EXTRACTION AND BENEFICIATION OF ORES AND MINERALS

VOLUME 7

PHOSPHATE AND MOLYBDENUM

**MINE SITE VISIT:
IMC FOUR CORNERS MINE**

Figure 5. Washer Plant Flow Diagram
(Source: U.S. EPA Field Note)

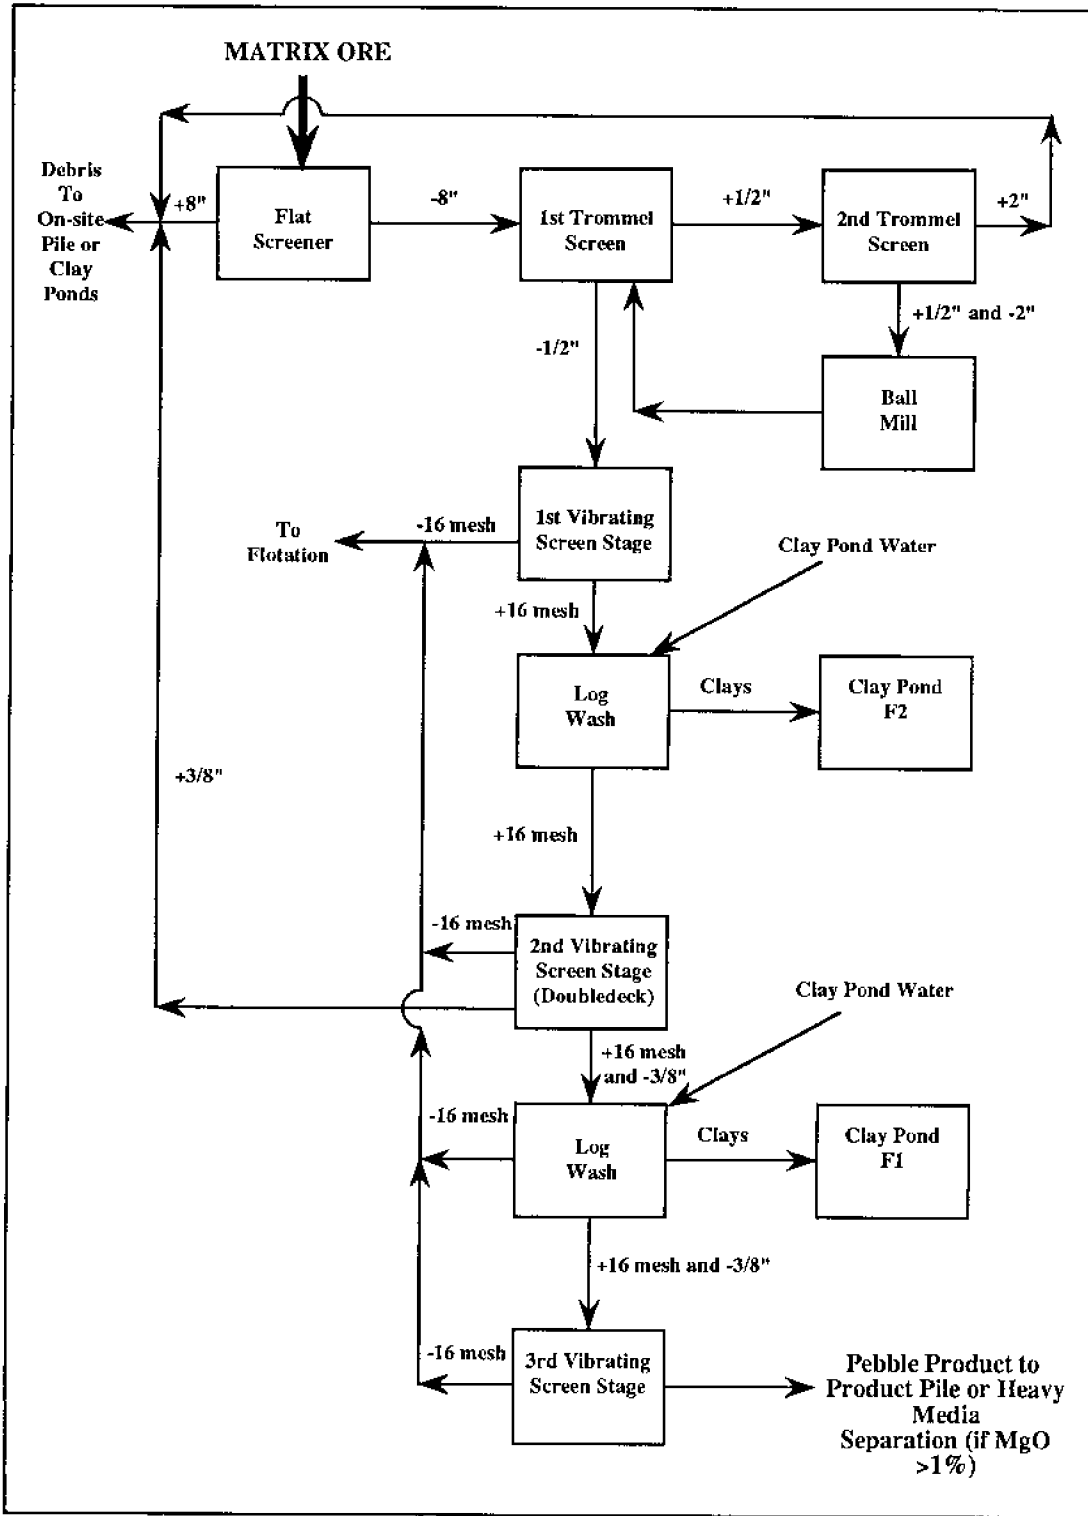
Page 16, Figure 5:

Replace this figure with the revised Figure 5 (attached). The original is not correct.

Figure 2: Cyprus Thompson Creek Site Map
(Source: Cyprus, provided at Site Visit)

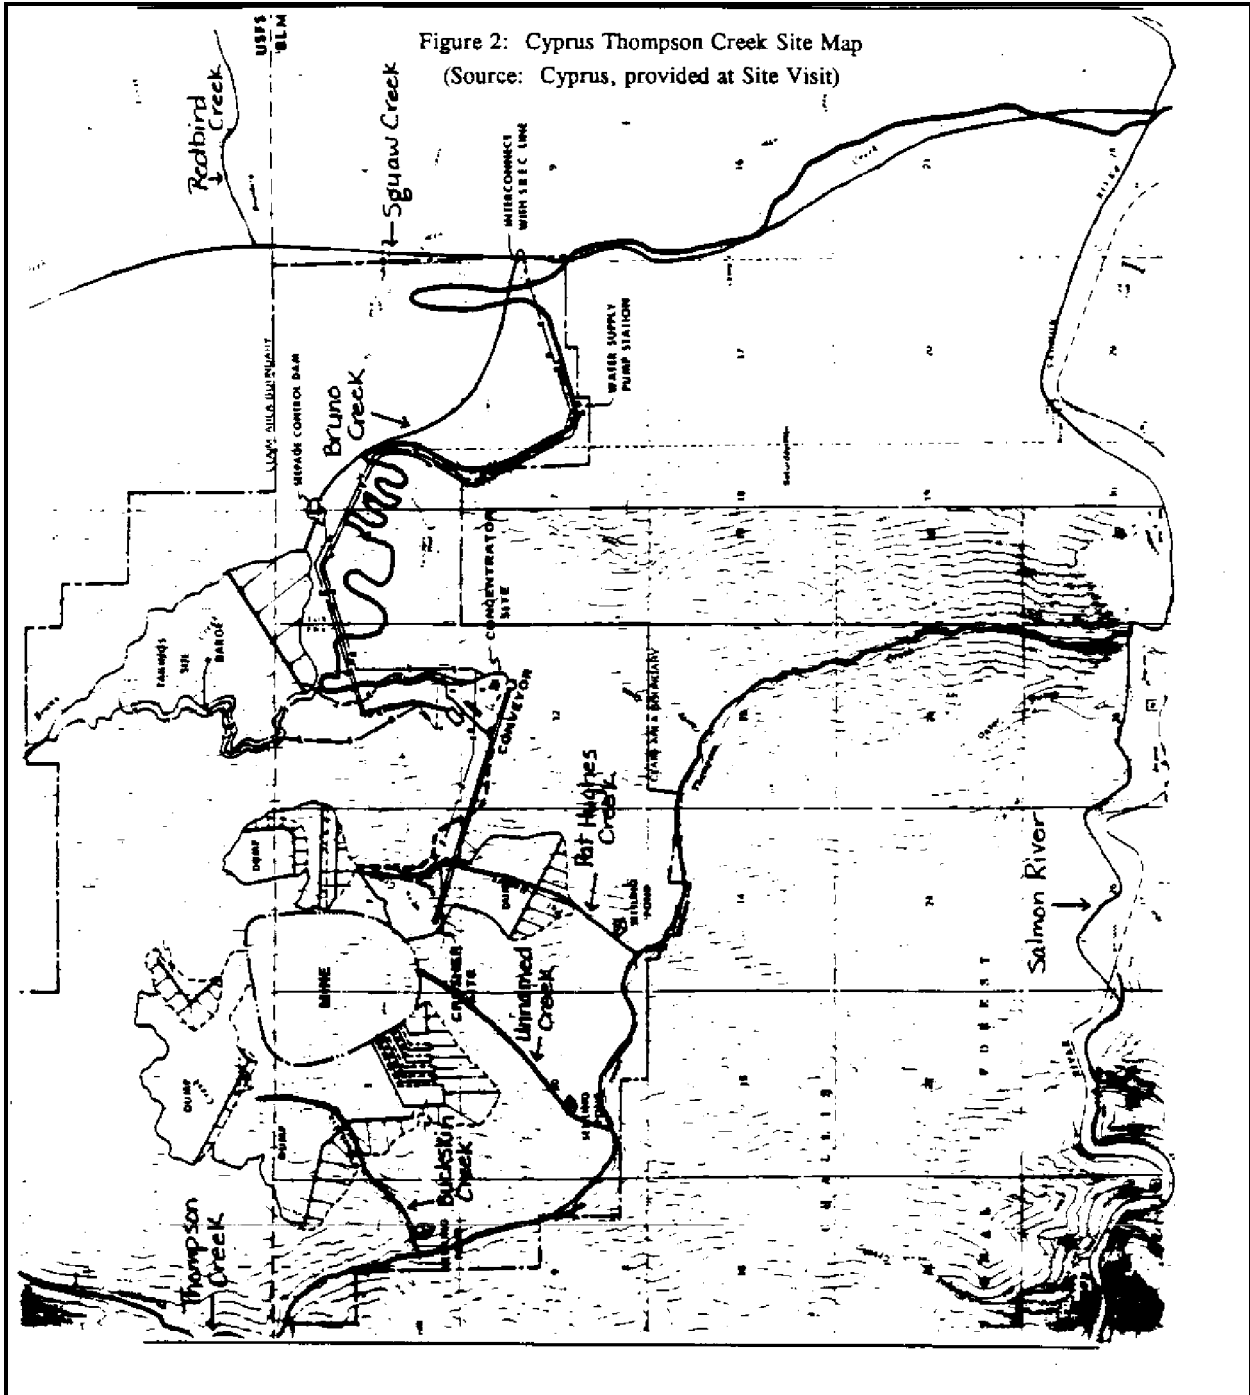
Page 5, Figure 2.: The figure shows a non-existing "unnamed creek" flowing from the pit to the Salmon River between Pat Hughes Creek and Buckskin Creek. It also shows a settling pond on this unnamed and non-existing drainage. This Figure should be corrected.
